ZONING BOARD OF ADJUSTMENT, PANEL C  
MONDAY, AUGUST 24, 2015  
AGENDA

<b>BDA 145-063</b>	1712 Commerce Street <b>REQUEST:</b> Application of Ed Simons for variances to the front yard setback and minimum sidewalk regulations, and a special exception to the landscaping requirements	1
--------------------	---	---

**FILE NUMBER:** BDA 145-063

Exhibit 1.  
 Sidewalk Inventory, Existing Conditions  
 1712 Commerce Street

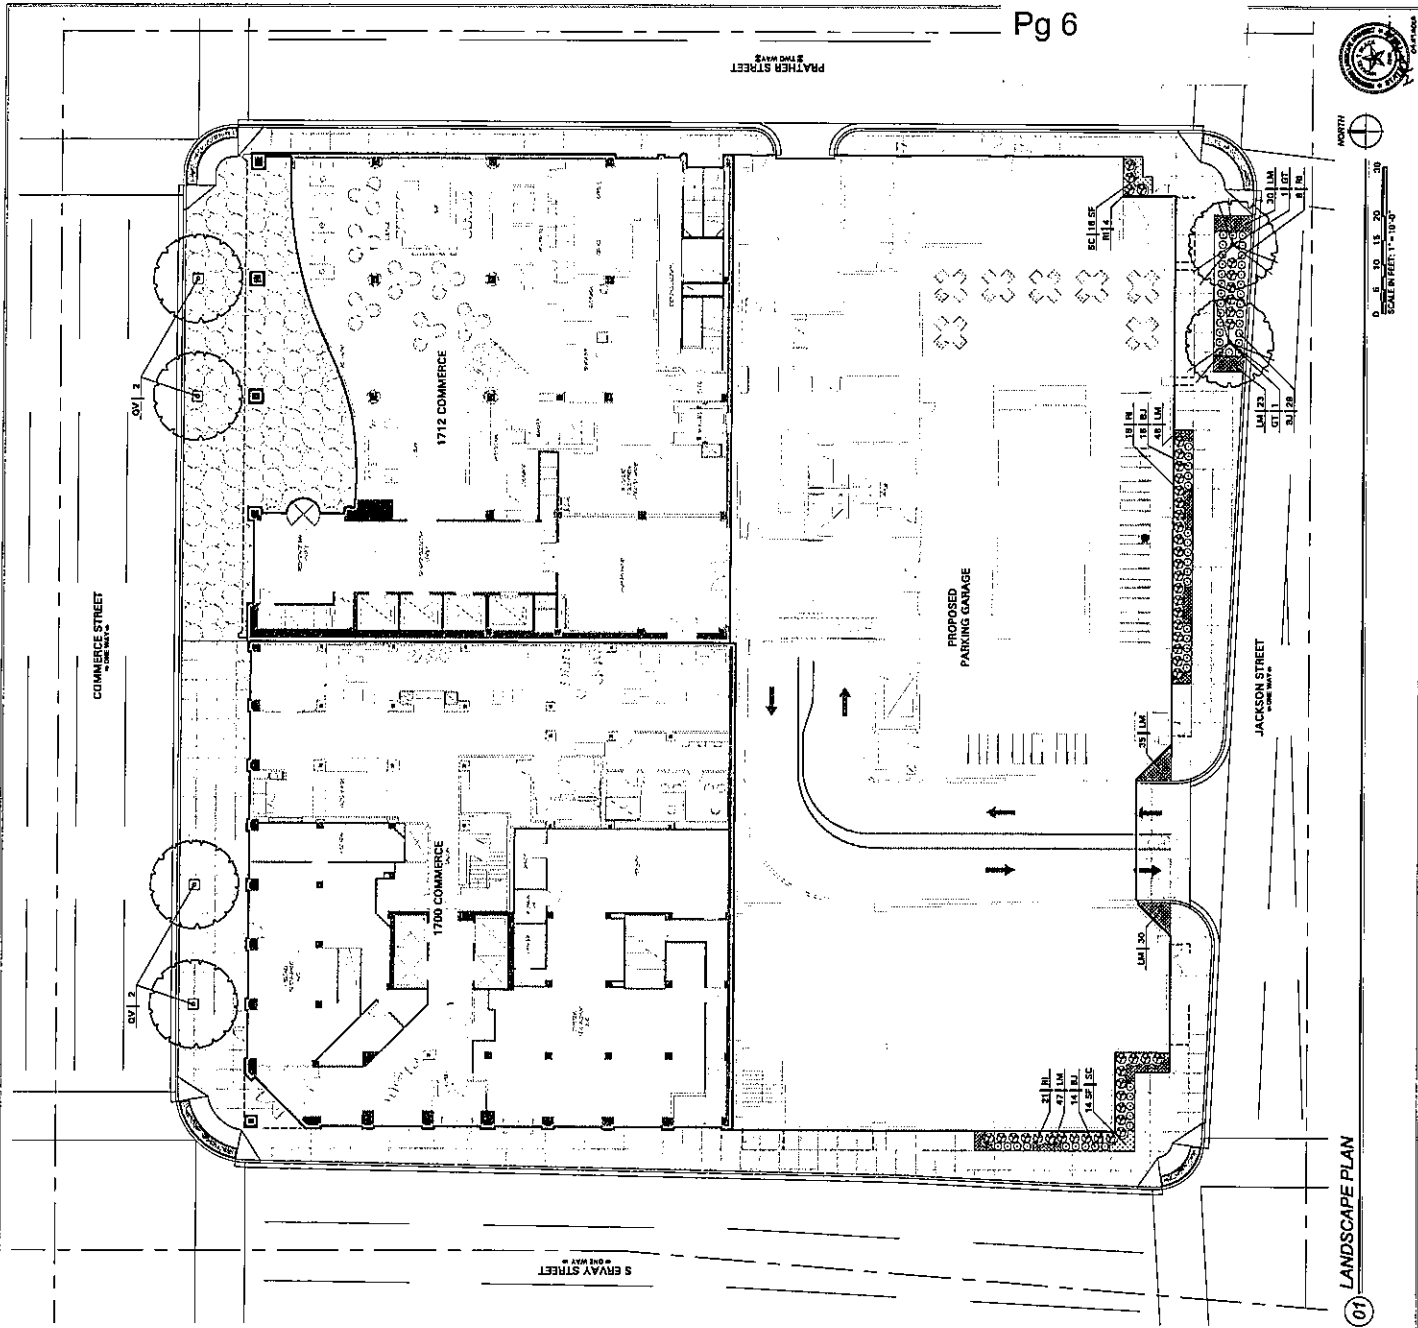
Exhibit 1 depicts a summary of the sidewalk inventory. As shown, within about two blocks of the site in all directions, many existing sidewalks provide less than ten feet of building setback.

PARKING GARAGE SITE PLAN  
SCALE: 1/8" = 1'-0"

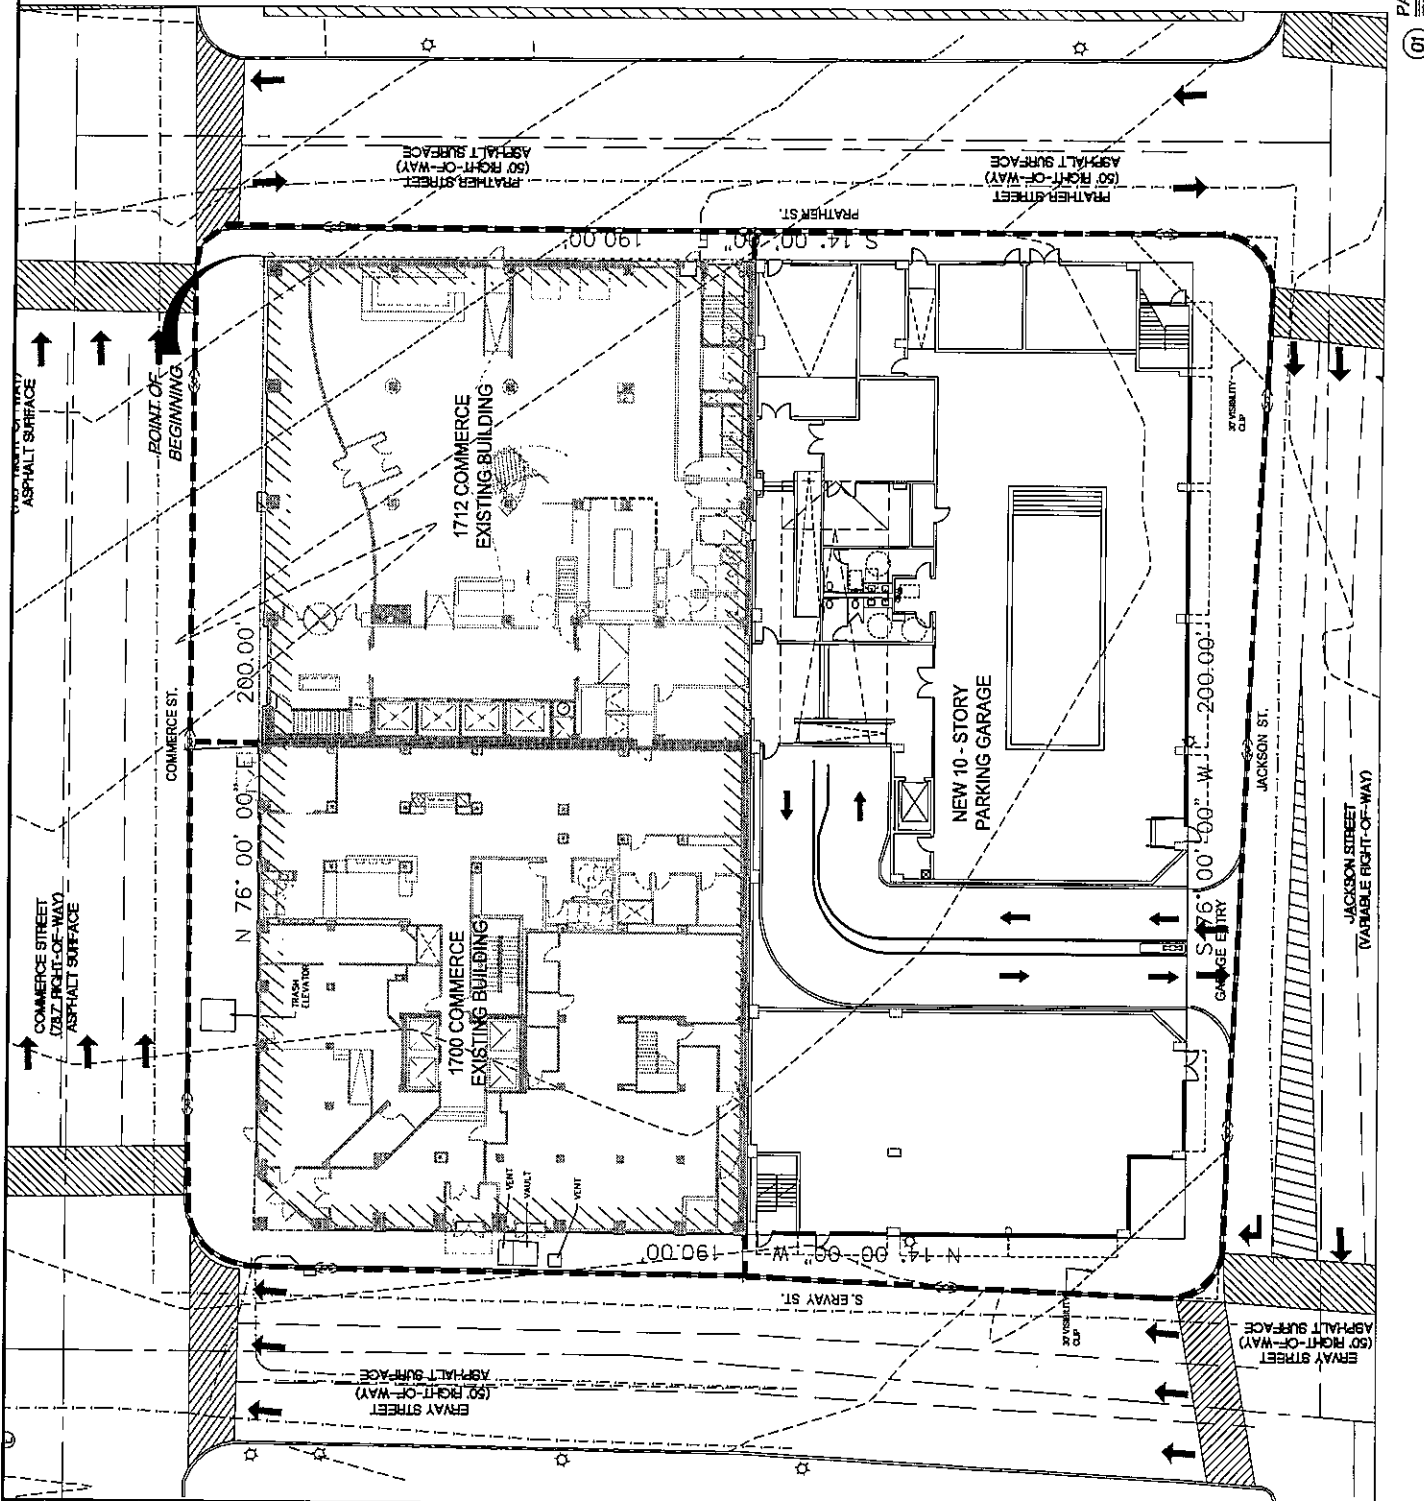
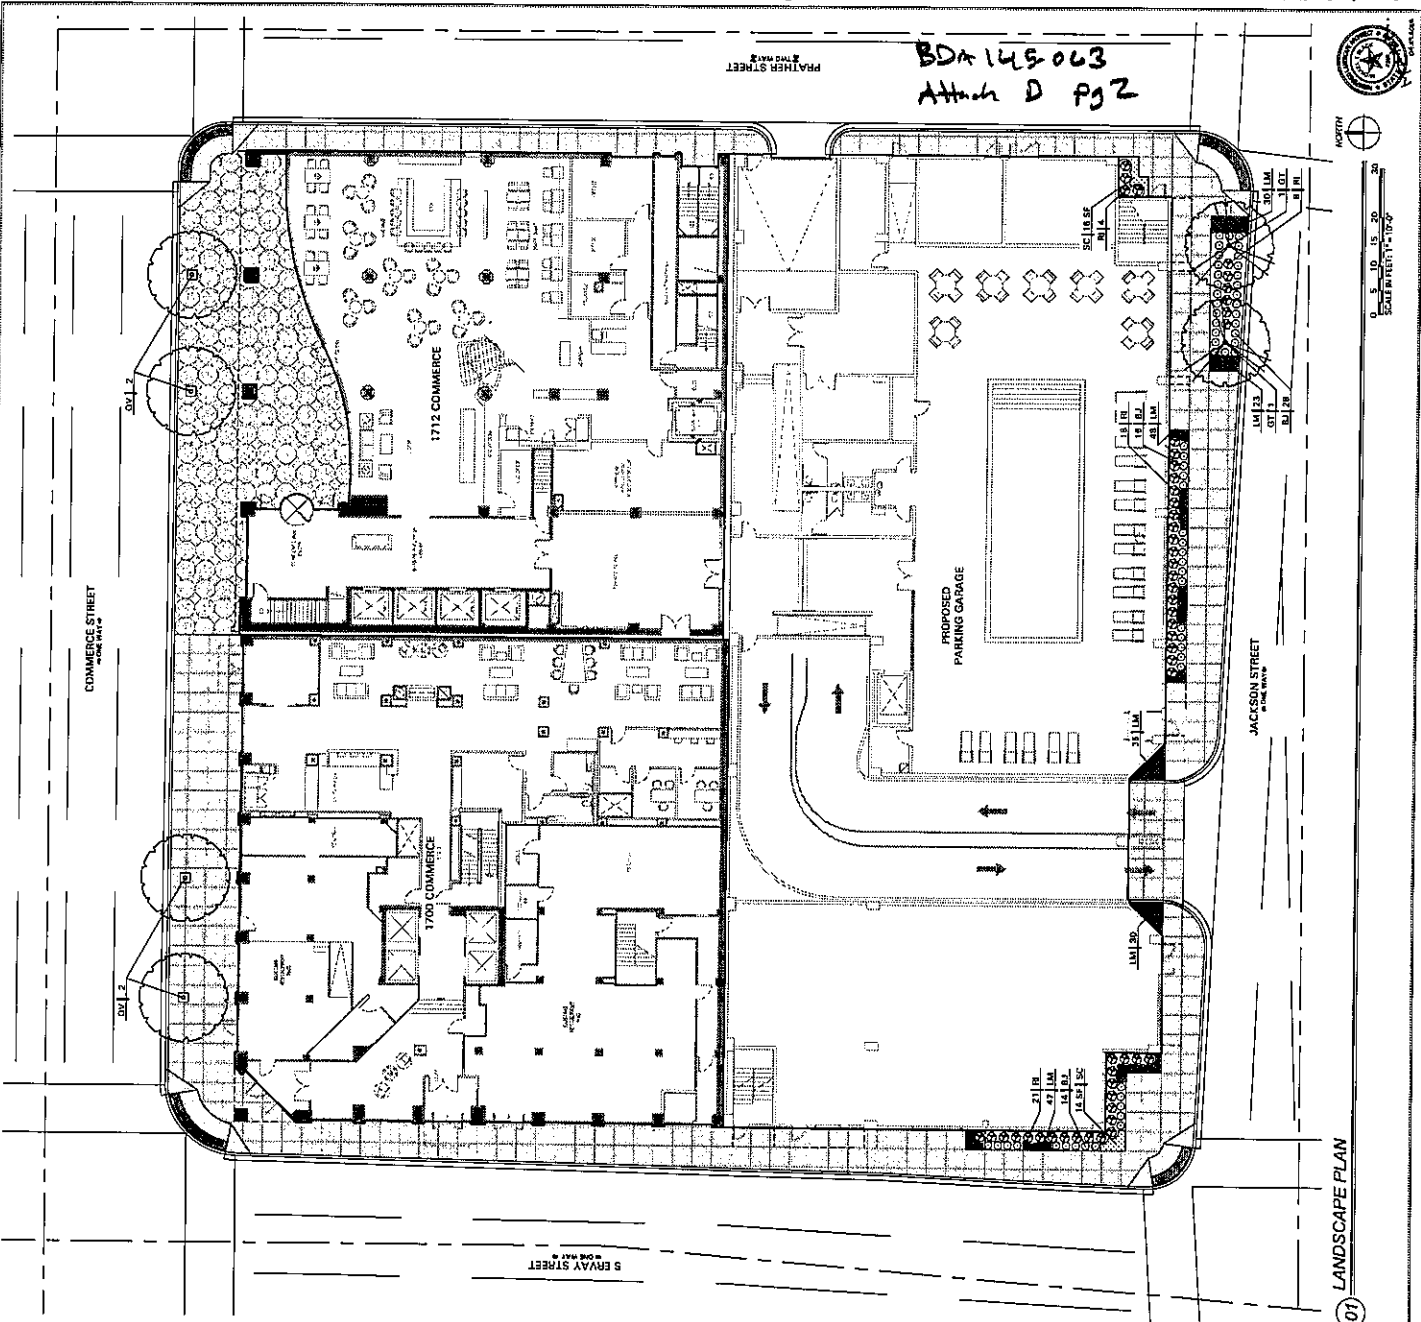
- A revised site plan has been submitted that indicates a structure as close as 5' from the S. Ervay Street, Jackson Street, and/or Prather Street curb lines or as much 5' into these 10' required front yard setbacks.

- A revised site plan has been submitted that indicates sidewalks along S. Ervay Street, Jackson Street, and Prather Street at a minimum 5' width.
- While the revised site plan indicates that sidewalks around the existing structures on the site do not comply with the sidewalk regulations, the applicant has stated that his application is only focused on sidewalks around the new parking garage structure and not to remedy any aspect of nonconforming sidewalks around the existing structures on the subject site.

01 LANDSCAPE PLAN

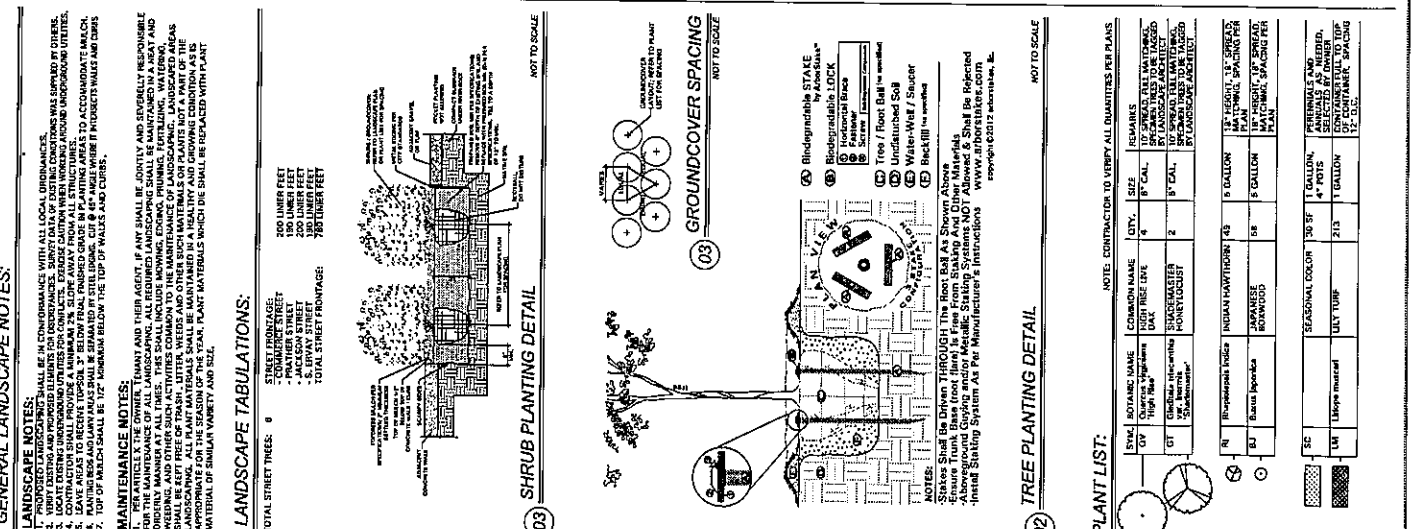
- The City of Dallas Chief Arborist’s memo identifies that the deficiencies in this case are: 1) that tree grates are required for all trees planted in a public sidewalk where the applicant is proposing trees situated in an open planting bed, and 2) that shrubs are required to be a minimum of 30” in height where the applicant is proposing 18” shrubs.

The proposed alternate landscape plan does meet or exceed the required 'one tree or one shrub in the adjoining parkway for each 30 feet along the frontage abutting the right-of-way.' The plants (mainly shrubs) are distributed to primarily face Jackson and Ervay streets. However, tree grates are required for all trees planted in a public sidewalk. The trees are situated within an open planting bed. The shrubs shown at 18" height do not comply with the requirement of a minimum of 30" height.

The chief arborist recommends denial of the proposed alternate landscape plan because the applicant has not proven strict compliance with the landscape requirements of this district would result in unnecessary hardship.
